Product Change Notice (PCN)

PCN Number: PCN-0381408R-01

Product(s) Affected: CMS-160916-30-3

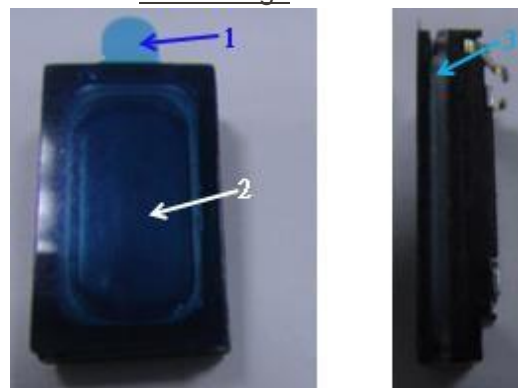
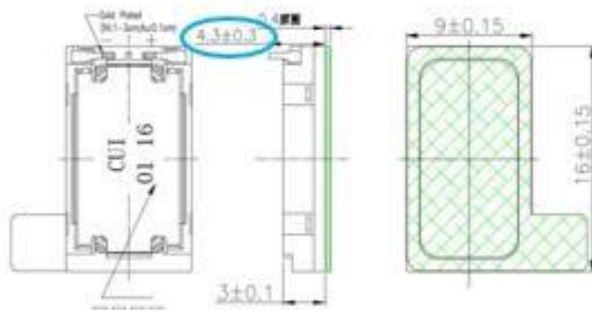
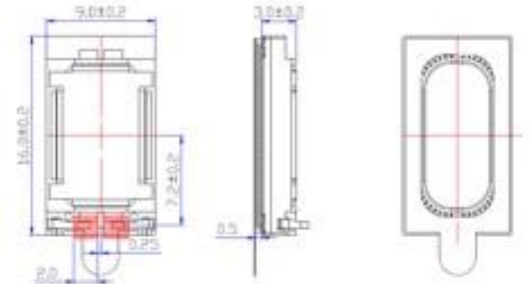
Description of Change: *Power rating change to 0.8W rated; sound pressure level change to 88dB @ 0.8/10cm; resonant frequency change to 600Hz; THD change to 15% max; multiple housing/appearance modifications as shown below:*
